# CITY OF ALBUQUERQUE

**Re: Ceja Vista/ 10001 Ceja Vista Rd. SW**  
**Request for Certificate of Occupancy**  
**Transportation Development Final Inspection**  
Architect's Stamp dated 11-25-2019 (P09-D002G)  
Certification dated 07-11-23

RE: Ceja Vista  
10001 Ceja Vista Road SW  
Zone: R2  
Submittal: TCL for Final C.O. of Phase 1

CEJA VISTA  
10001 CEJA VISTA ROAD SW  
ALBUQUERQUE, NEW MEXICO 87121

SDP1.1

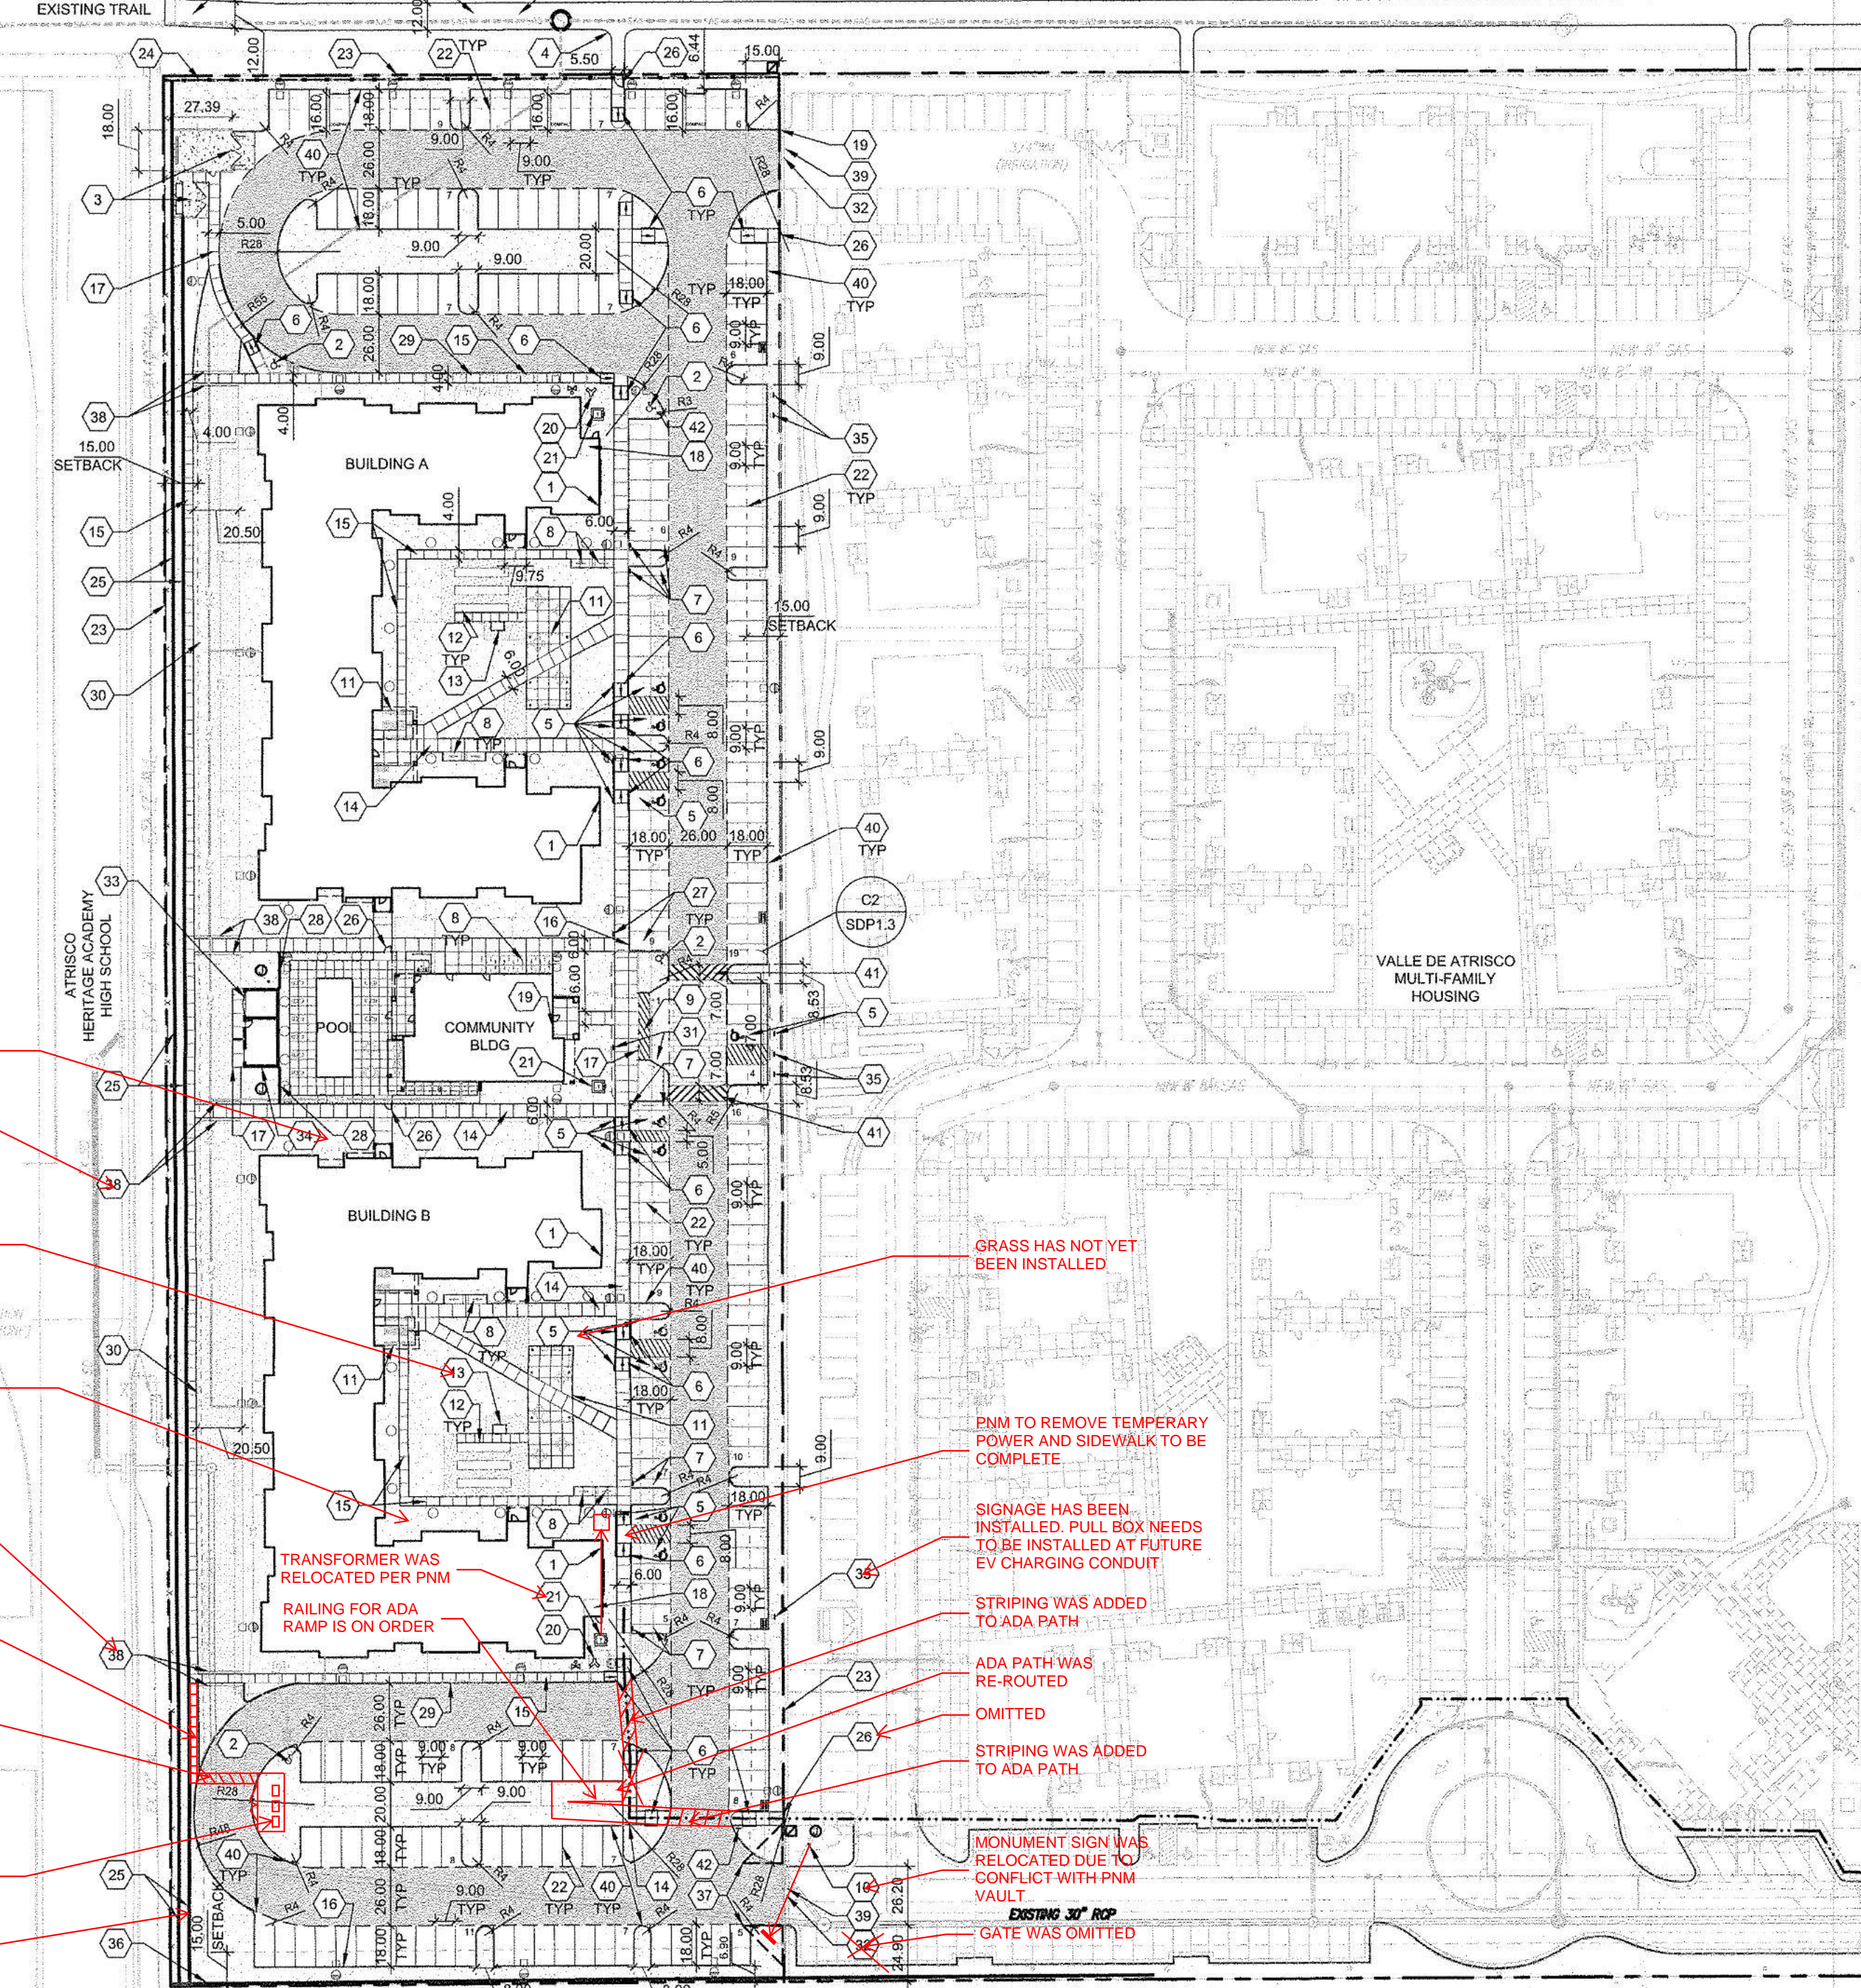
Victoria Crook with Dekker/Perich/Sabatini visited the project site on my behalf on 06/27/2023 to verify construction was in accordance with the attached Site Development Plan. The following items are noted to differ from the approved site development plan:

- Plants have not yet been installed on North side of Building B
- Concrete mountable curbs were omitted at West end of Building B
- Potting table is not yet onsite
- Grass has not yet been installed at Building B Courtyard
- Sidewalk was extended to reach ADA path to Trash Enclosure
- Trash Enclosure was added to the project
- Second retaining wall was omitted at West end of site
- Transformer for Building B was relocated due to lack of room at original location
- Railing for ADA ramp is on order
- PNM needs to remove the temporary power and the sidewalk where it is currently located needs to be placed
- Signage for future EV charging station is installed. Pull box needs to be installed at conduit.
- Striping was added to ADA path

- ADA path was re-routed
- Pedestrian gate was omitted
- Monument sign was relocated due to conflict with PNM vault
- Vehicular gate was omitted
